Moody Nolan

Addendum

Project	The Falls on Refugee Road	**Addendum Number**	2
Project Number	23446	**Date**	06/27/2025
To	All Bidders

1 OVERALL LANDSCAPE PLAN

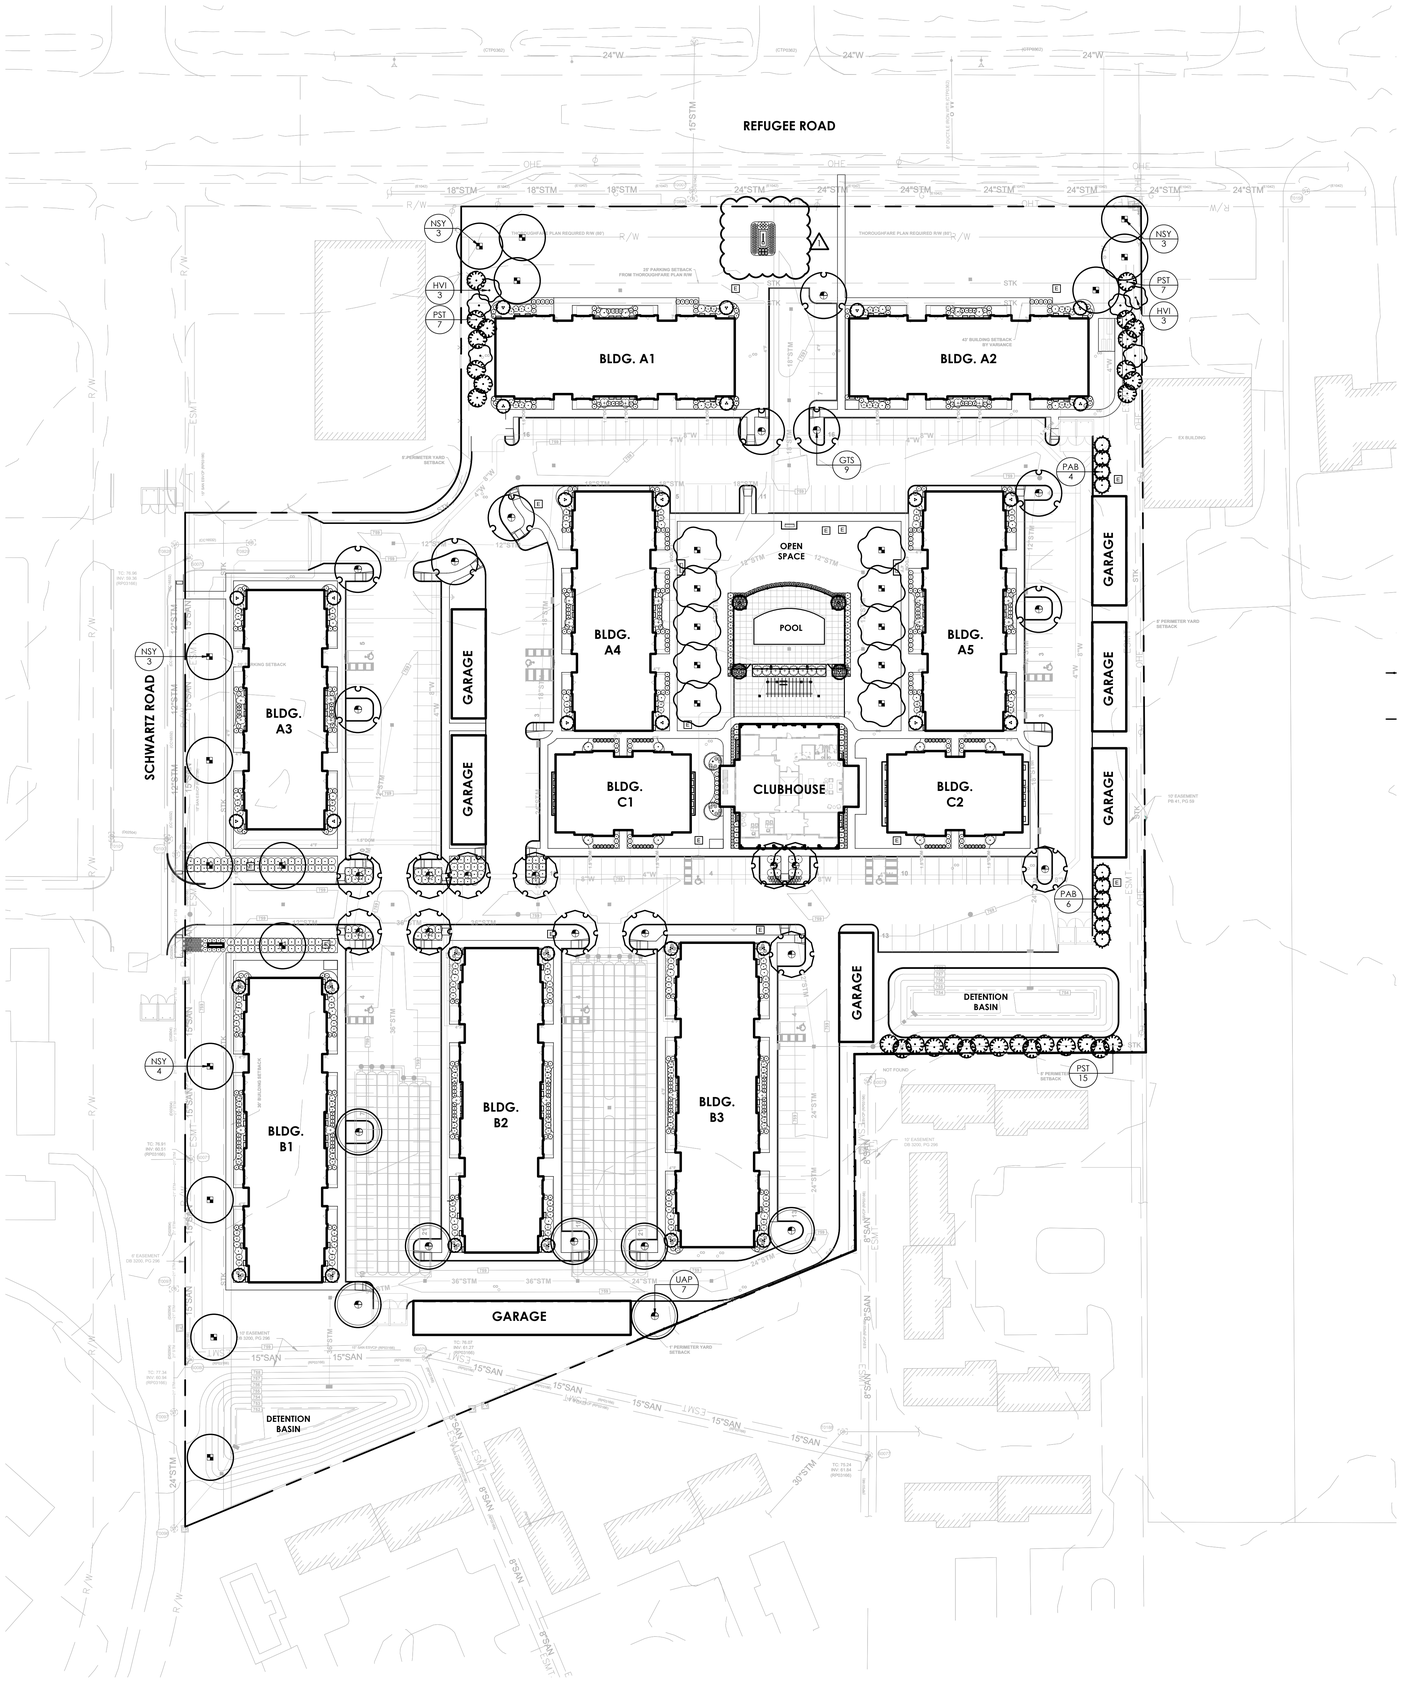
1. L1.01 - LANDSCAPE PLAN - OVERALL SITE
    a. Add sign location along Refugee with associated landscaping. Quantities specified on L1.02.
    b. Updated entry drive revision along Refugee. Adjust seed coverage amount.

1 LANDSCAPE PLAN - SOUTH

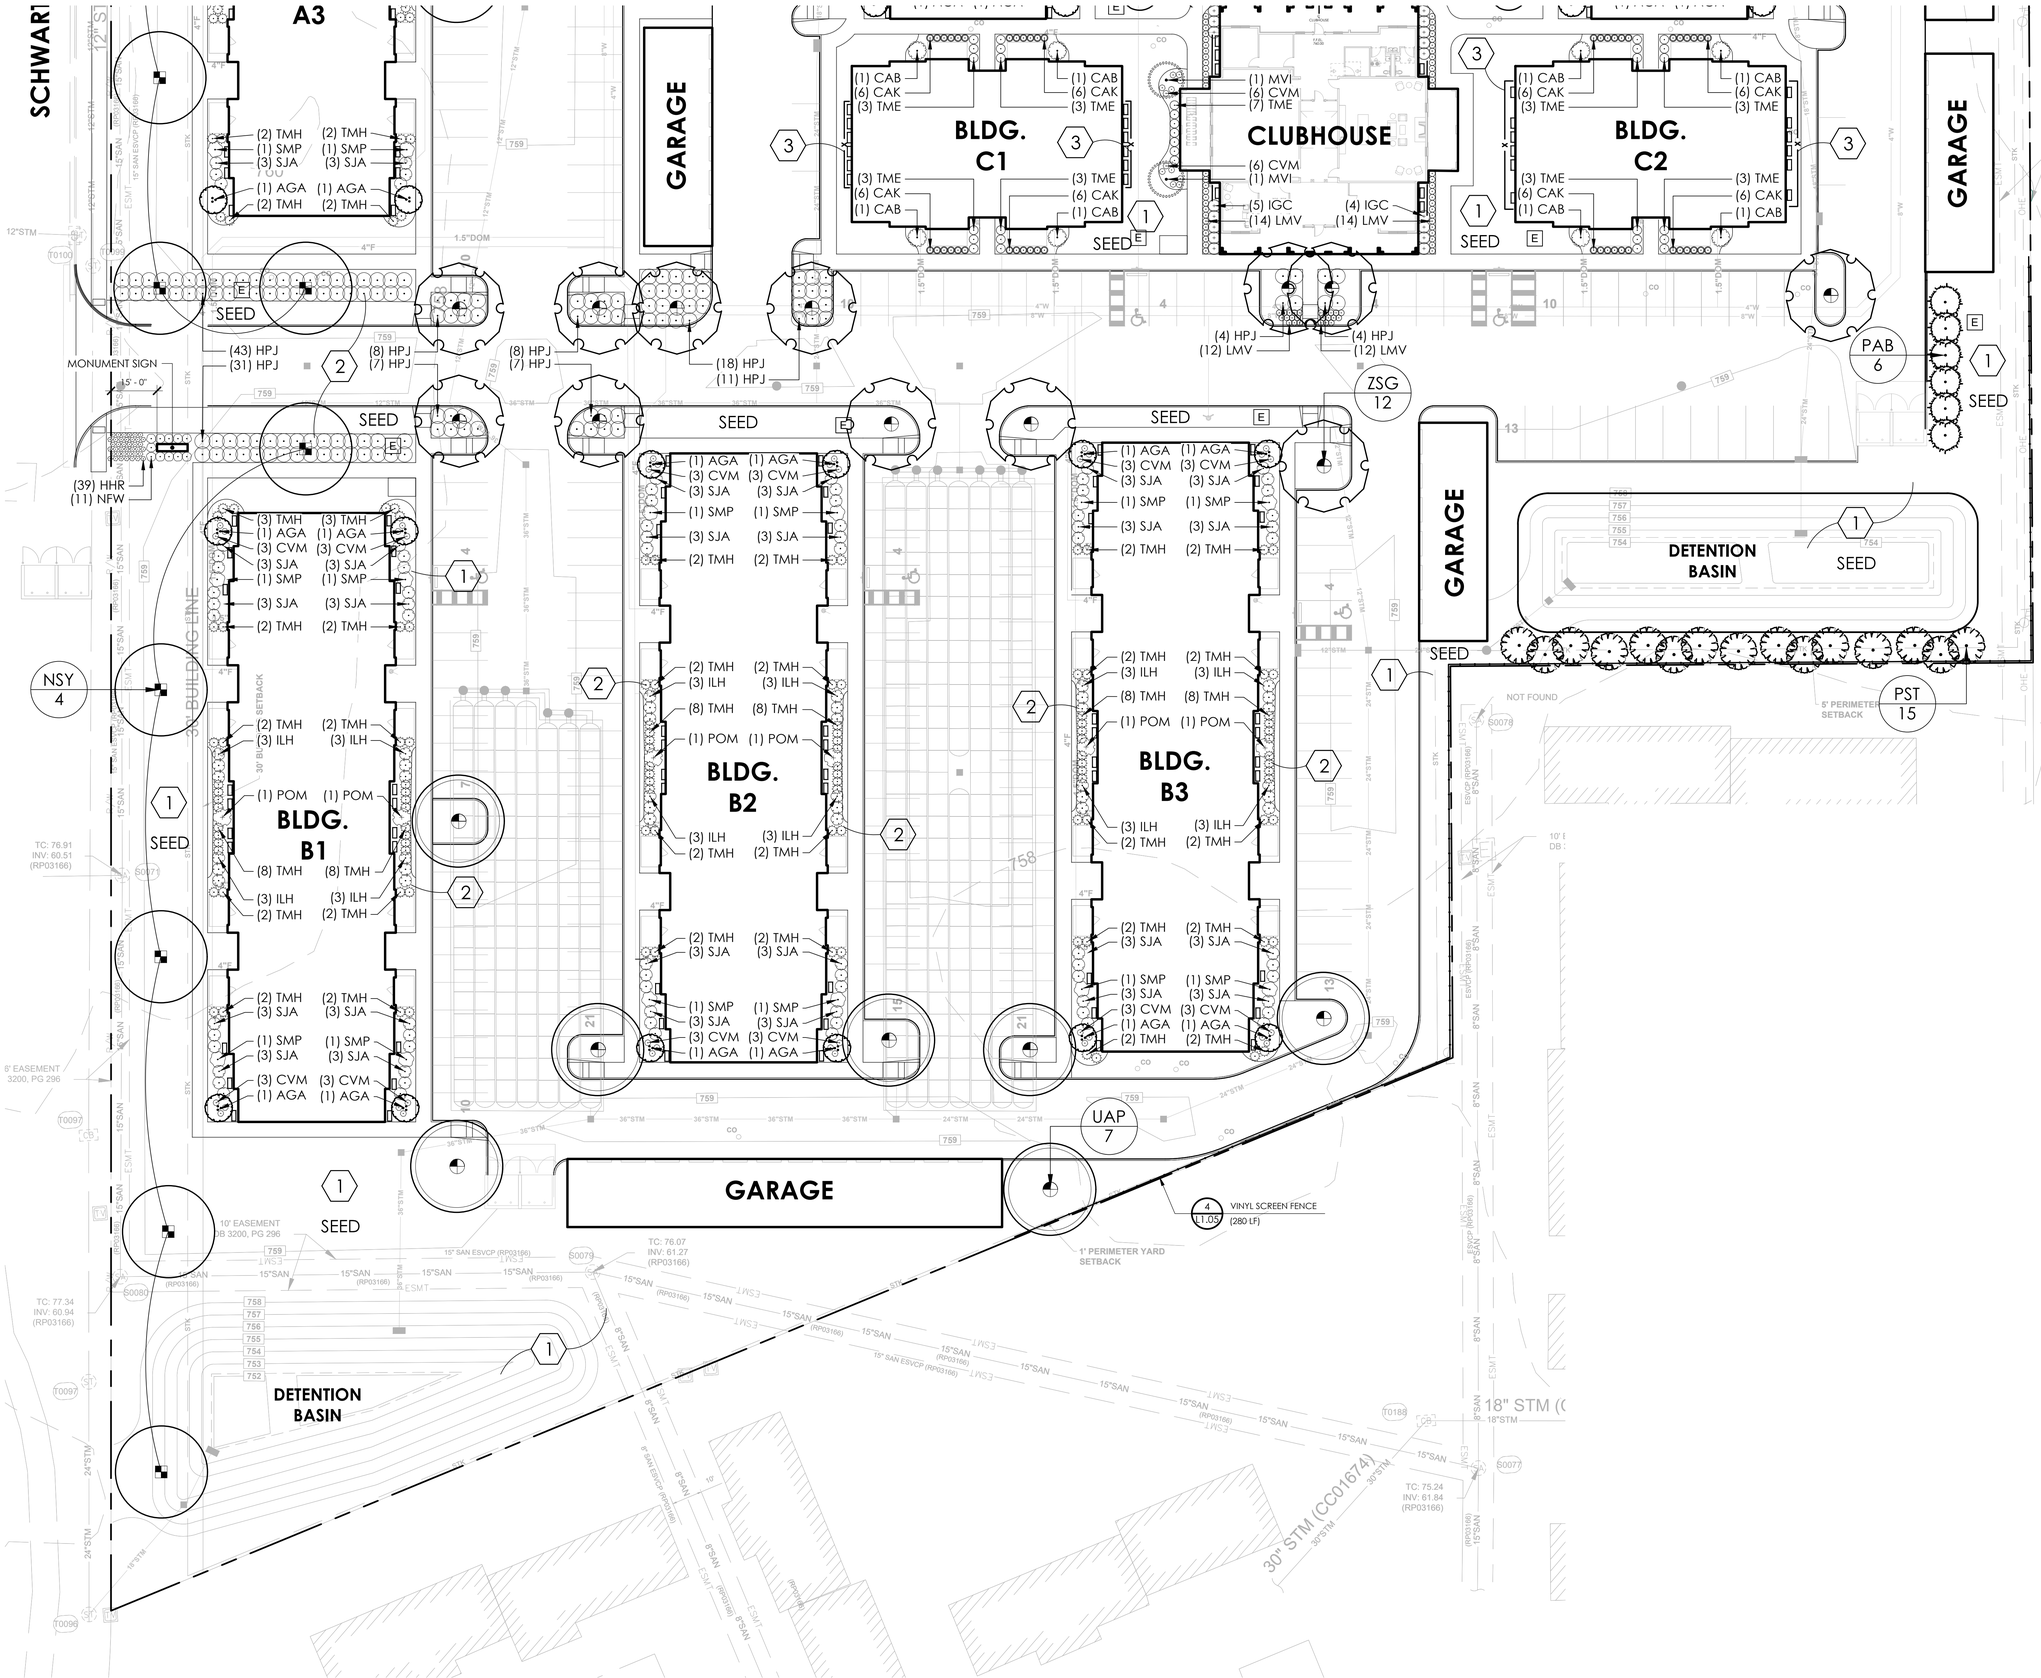
3. L1.03 - LANDSCAPE PLAN - SOUTH
    a. Adjusted plant layout and quantities for transformer locations.

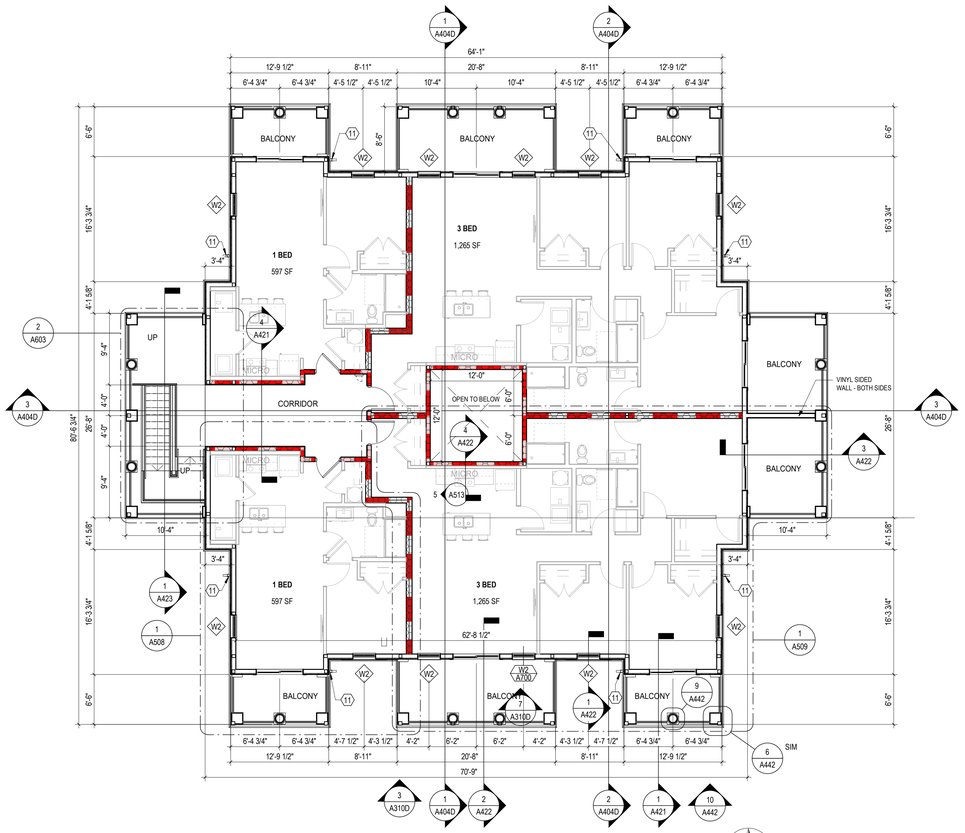
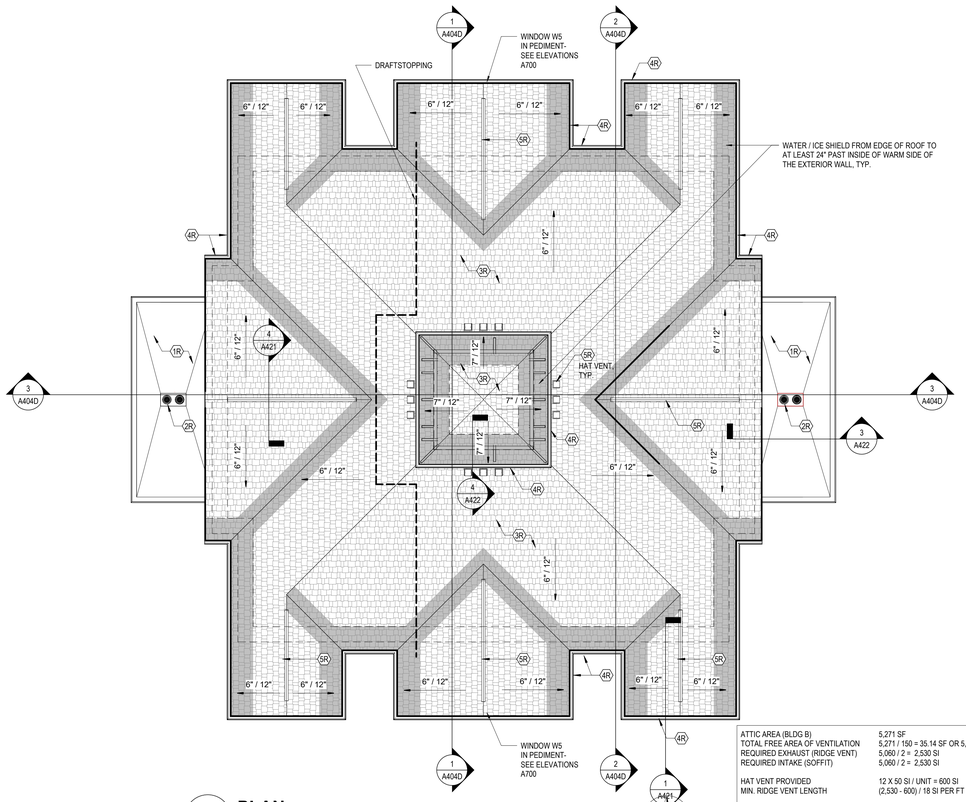
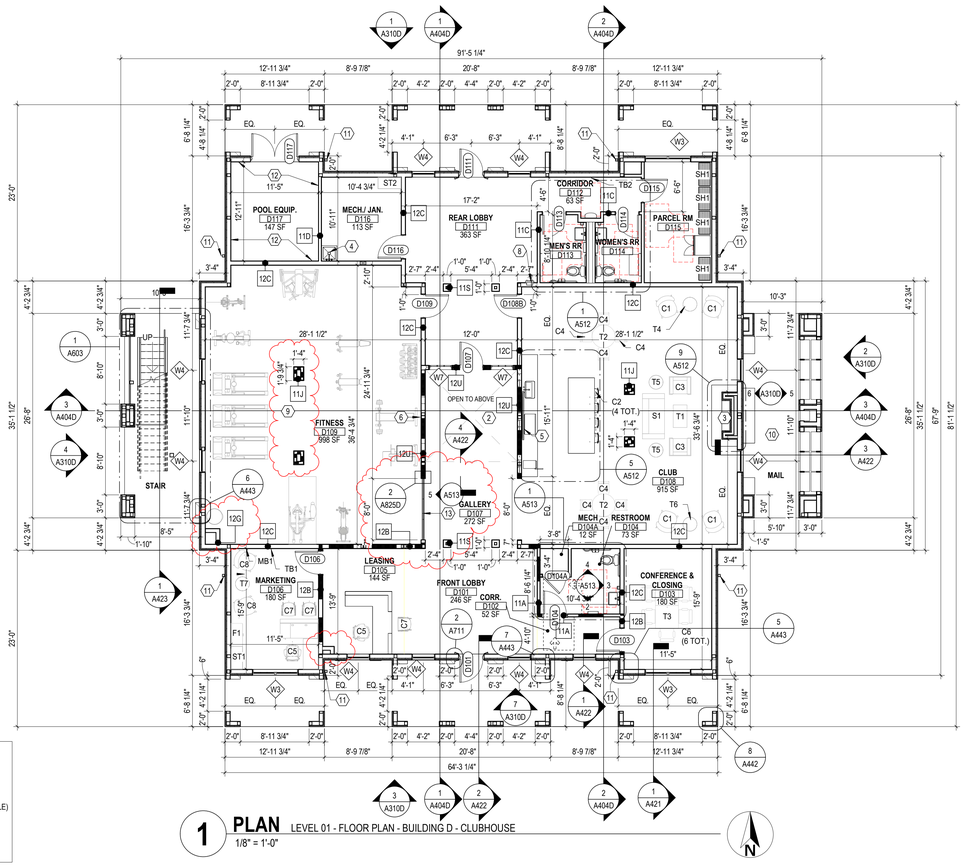
1) G001 - DRAWING INDEX
   i) Added sheet G150, A350A, A350B, A350C, A350D, A351, A423, A444,
   ii) Deleted Sheet A931
   r
2) G100A – BUILDING A LIFE SAFETY
   i) Relocated attic access panels
3) G100B – BUILDING B LIFE SAFETY
   i) Relocated attic access panels
4) G100C – BUILDING C LIFE SAFETY
   i) Relocated attic access panels
5) G150 – SIGNAGE SCHEDULE
   i) Sheet added to set
6) G200 – BUILDING ASSEMBLIES SCHEDULE
   i) Deleted demountable glass system schedule
7) G400A – BULDING A – GROSS AREA
   i) Revised areas for sprinkler rm
8) G400B – BULDING B – GROSS AREA
   i) Revised areas for sprinkler rm
9) A106D- CLUBHOUSE - FLOOR & ROOF PLANS
   i) Added Coded note 13

ii) Added demountable glass partition to the fitness area
iii) Adjusted sizes of column enclosures in fitness rm
iv) Add plumbing chases to fitness rm and leasing

11) A202A – BUILDING A LEVEL 03
i) Relocated attic access panel
ii) Revised breezeway ceiling to vinyl soffit
iii) Added dimensions to balcony vinyl soffit

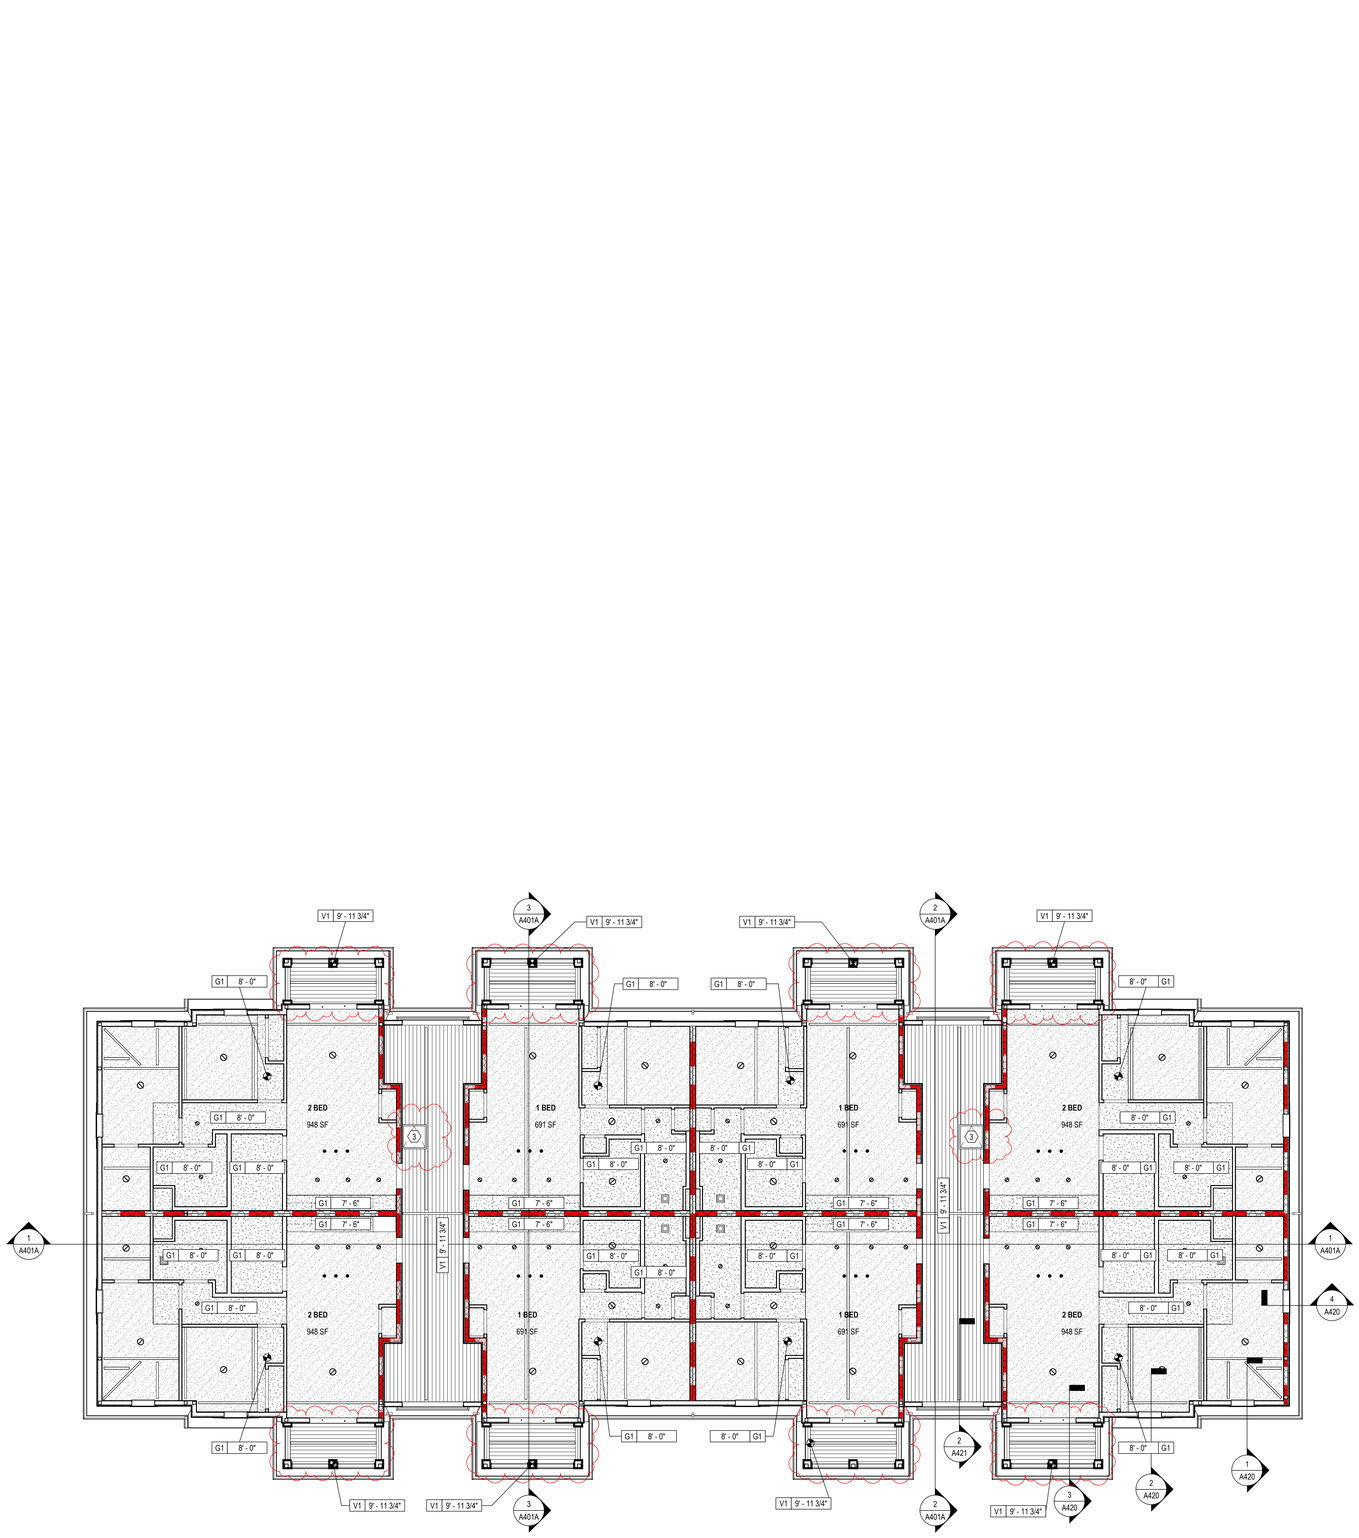
19. Sheet A202A shows Wood Grain pattern at Balcony Ceiling that does not correlate to the Legend, please confirm WD4 Wood Ceiling finish at these location. Same for A204B, A205C.
